REMEDIATION WORK PLAN

**POPULAR HAND LAUNDRY
88 INGRAHAM STREET
BROOKLYN, NEW YORK**

**Dvirka and Bartilucci Consulting Engineers
Woodbury, New York**

August 1998

**LOCATION OF REMEDIATION
AND MONITORING SYSTEMS**

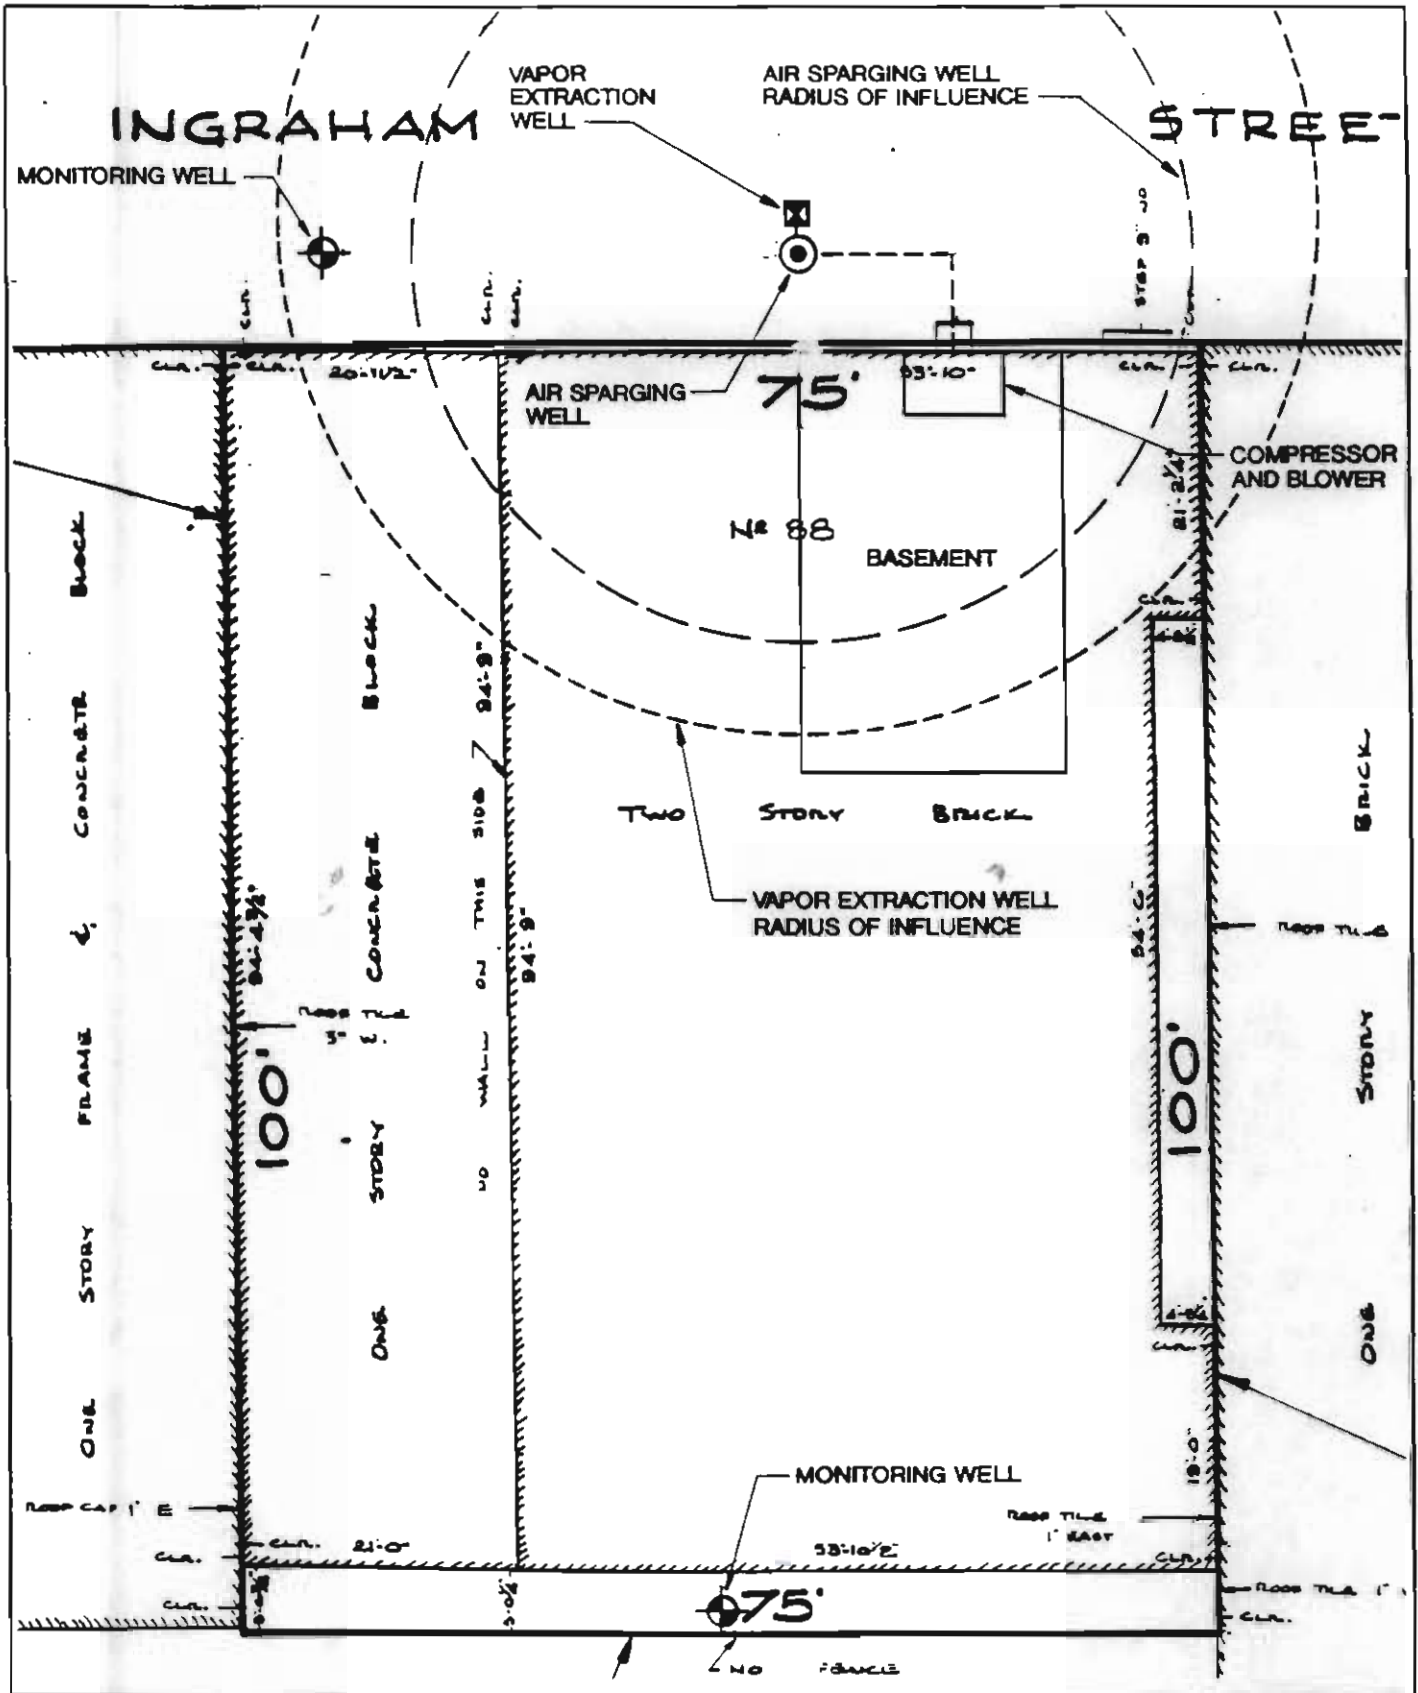
As we have agreed in the past, it is appropriate that the system be placed in front of the building. What had not been discussed in detail was the area which needs to be remediated. You have proposed one sparge point with an anticipated radius of influence of 30 feet. Based on the observed concentrations from the three groundwater samples taken in front of the building, the minimum area that must be influenced by air sparging would be contained within a radius of 20 feet from the point previously proposed as the location for the air sparging well. There must be some demonstration of the determination of the pressure and flow rate to be used that will cause the desired remedial effect, while at the same demonstrating that it does not significantly alter the groundwater gradient so as to cause the contaminants to be driven away from the source area.

The second concern on the sparge point is the selection of the depth and size of the screened interval. It is indicated in the work plan that the top of the screened interval will be located immediately below the water table and will extend 10 feet below the water table. Current literature on air sparging discusses both of these issues: first, it would seem that screen lengths longer than three feet do not increase the performance of the system, and second, the top of the screened interval is placed below the zone of contamination. A recommended depth for this system is at least five feet below the surface of the water table. However, site specific conditions

On page 2 of the work plan, the construction and placement of the vapor extraction well is discussed. It is stated that the screened interval will extend to just below the wastewater discharge line from the building. As was indicated in my August 29 letter to you, the Department's preference is that the screened interval extend from above the elevation of the building's wastewater discharge line, not below it. Please modify the language in the work plan accordingly.

To capture the vapors released by the sparging well, one vapor extraction well will be installed which, based upon information from MEG, will have an anticipated radius of influence of approximately 40 feet based on the geologic information available for the site. The proposed location of this vapor extraction well and the anticipated radius of influence of this well is provided in Figure 1.

The vapor extraction well also will be constructed of 2-inch PVC casing and screen. The extraction screen will be approximately 12 feet in length extending from approximately 3 feet above the water table to approximately 8 feet below ground surface just above the wastewater discharge line from the building.

The groundwater monitoring system will comprise the sparging well and two monitoring wells; one located upgradient (south of the site building) and the second in the front of the site building to the west of the sparging well. The locations of the monitoring wells are shown in Figure 1. Installation of the upgradient monitoring well (on the Popular Hand Laundry property)
